Access Compliance Report

Public Rights-of-Way

Intersection ID: 47904	Main Street: CAMP_VERDE_LN	Cross Street: ROUND_ROCK_RD	Location: S
ADA ID: 3ED486BEE1E5	Ramp Type: BlendTrans2	Initial Pass/Fail: Fail	Overall Compliance: No
		Severity Score: 8.75

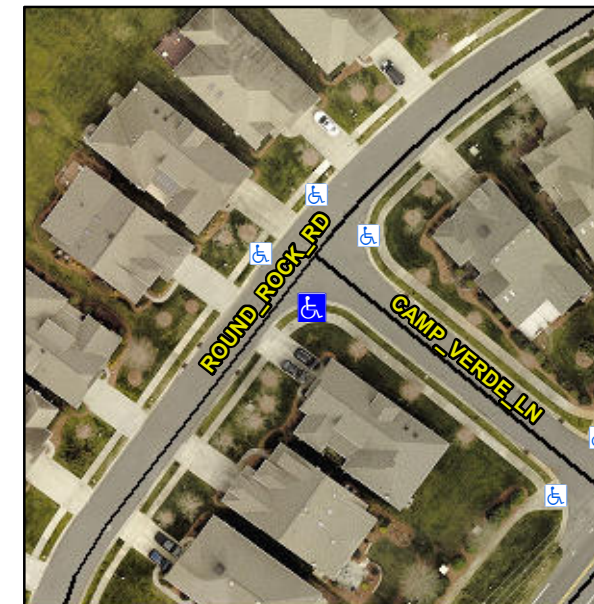
NO LNDG

Not Found, R304.5.1

Remove & Replace Curb Ramp With Two New Directional Ramps or Equivalent.
